Agenda
City of Springboro Planning Commission Meeting
Wednesday, June 12, 2024, 6:00 p.m.
Council Chambers, City Building, 320 West Central Avenue

Final Development Plan, 6821 Red Lion-Five Points Road, Bailey Farm PUD-R, Planned Unit Development, residential subdivision

Subject: Bailey Farm Staff Comments Response

FILE NAME
TYPICAL SECTION

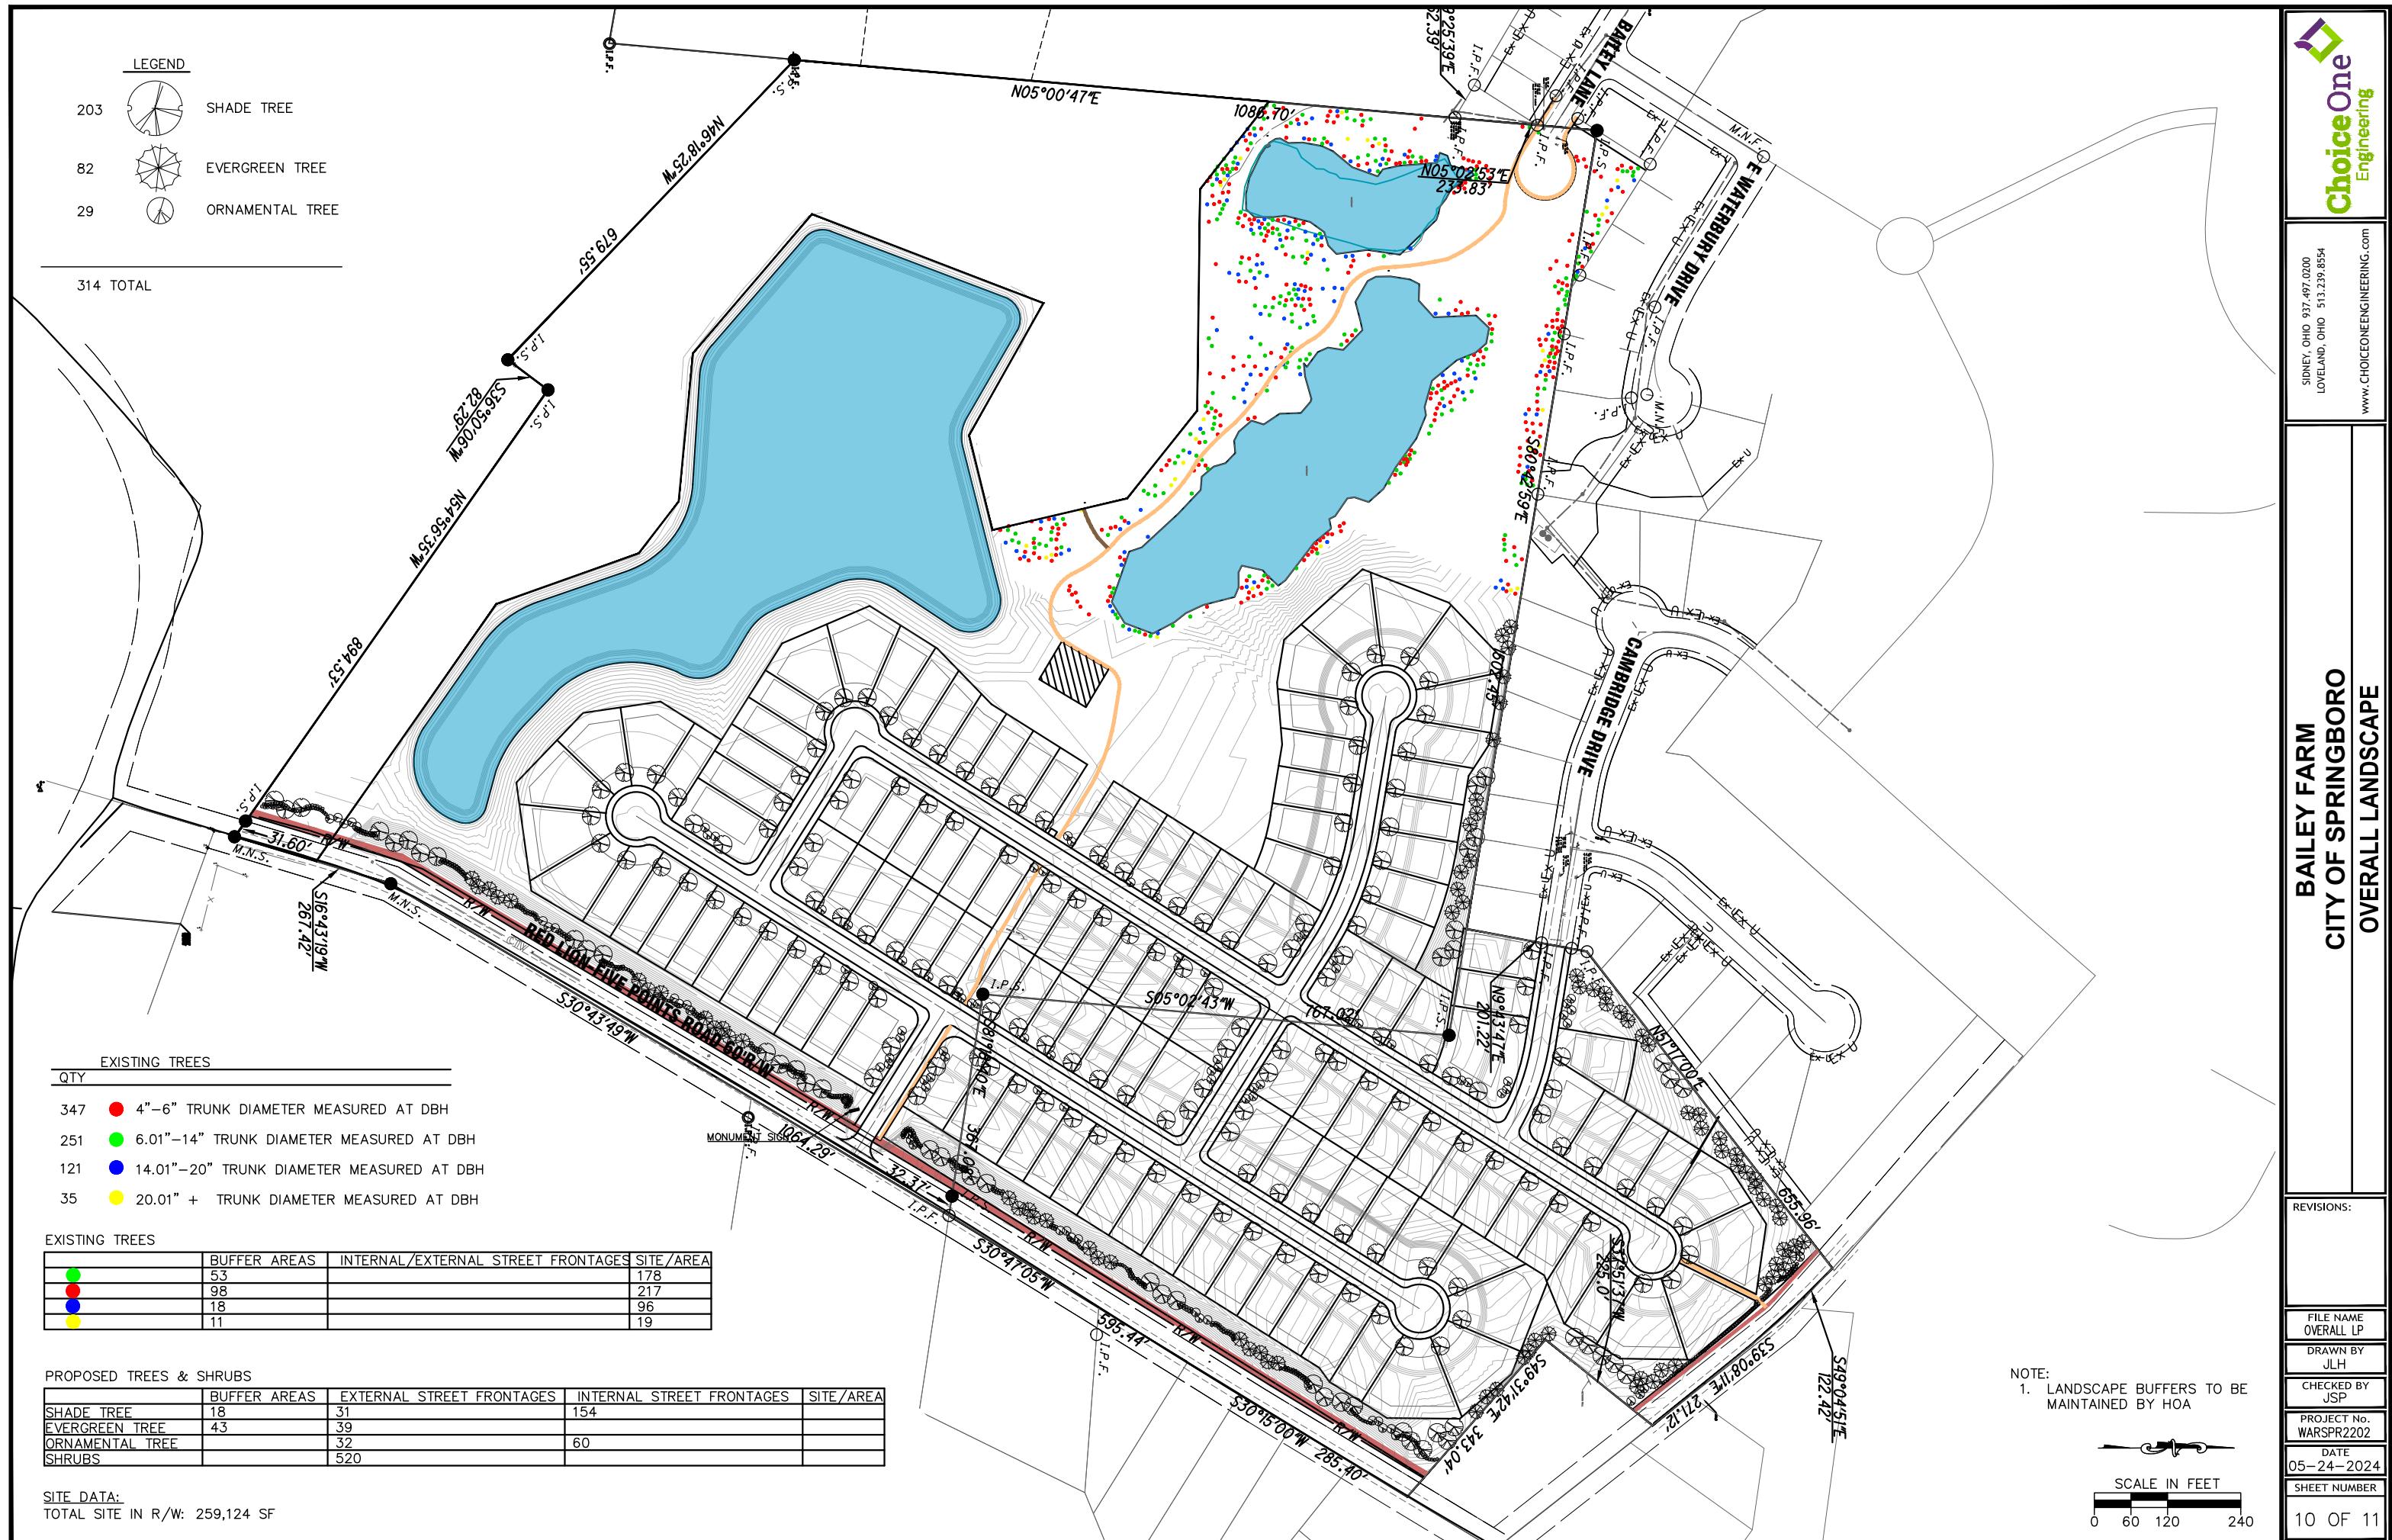
2. Revise information on sheet 3 of 11 to reflect on-site open space. **Revised**
3. The following comments apply to the proposed landscaping plan:
 - a. Provide metes-and-bounds to sheet 10 of 11. **Provided**

Ohio Utilities Protection Service
Call 811
before you dig
GRAPHIC SCALE IN FEET
0 20 40 60
SHEET NO:
C-201

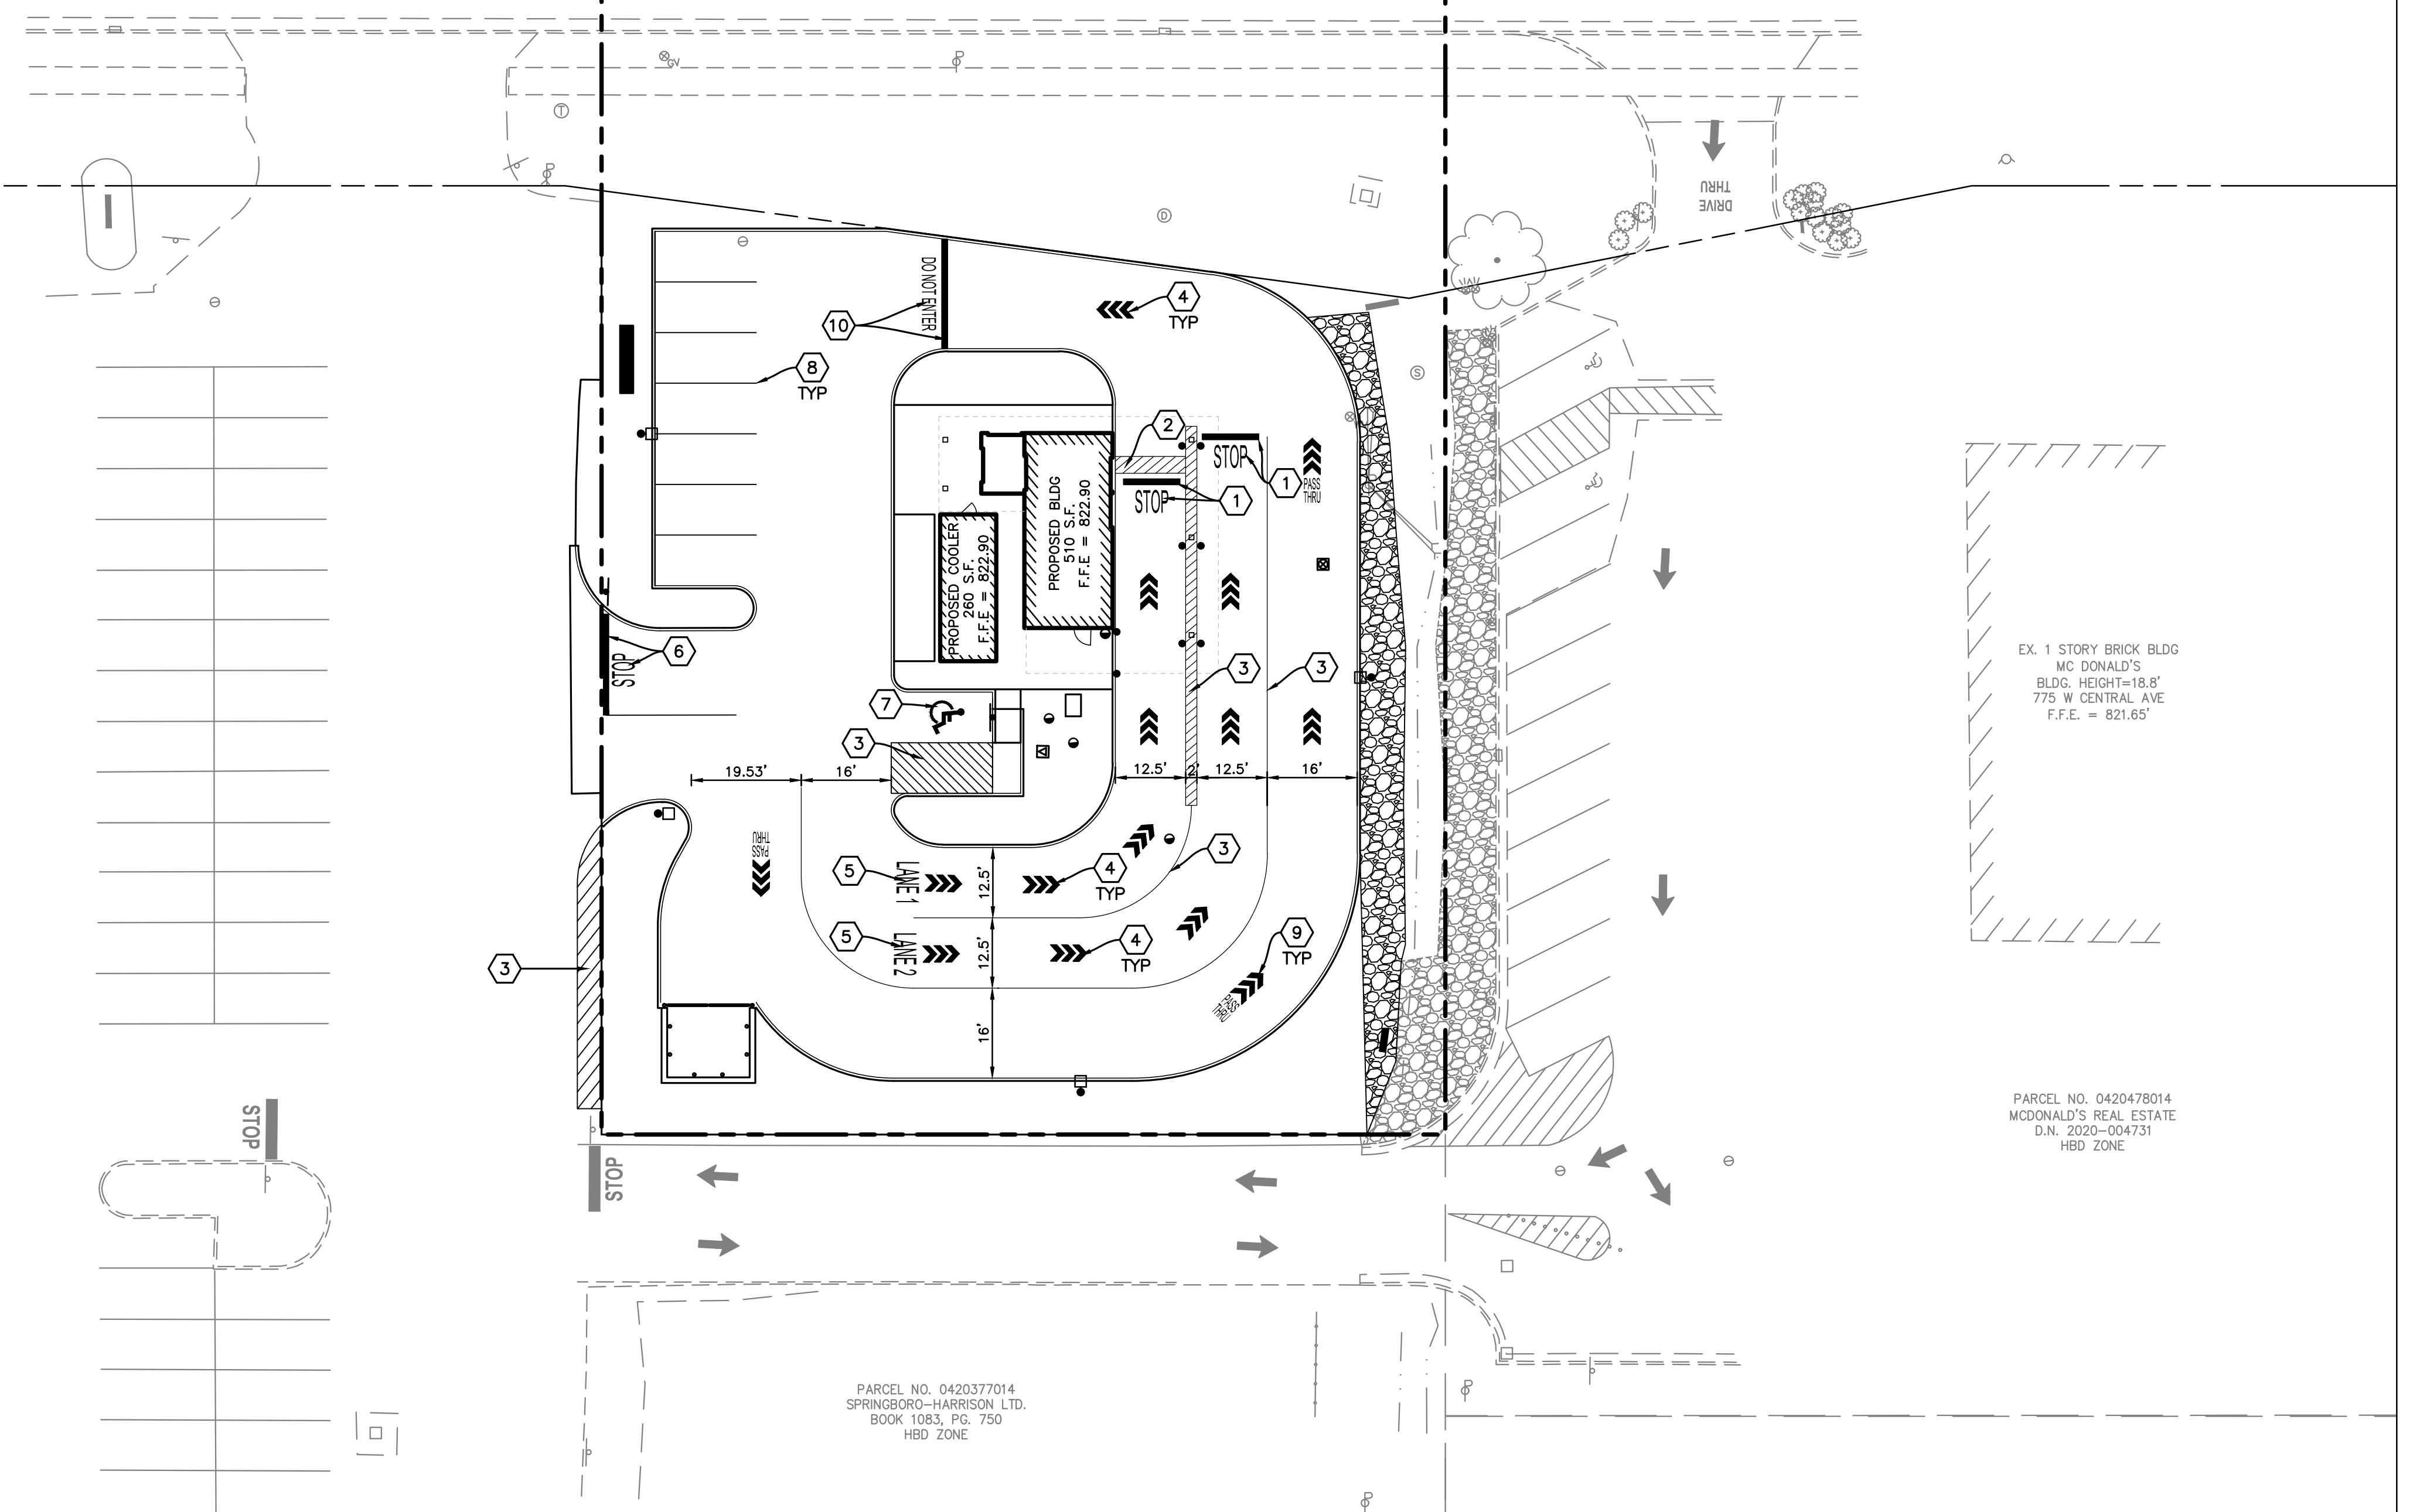
- 6. Create record plan dedicating the existing right-of-way along West Central Avenue.
- 7. Parking to be minimum 9 feet from property line (northwest corner of site does not meet).
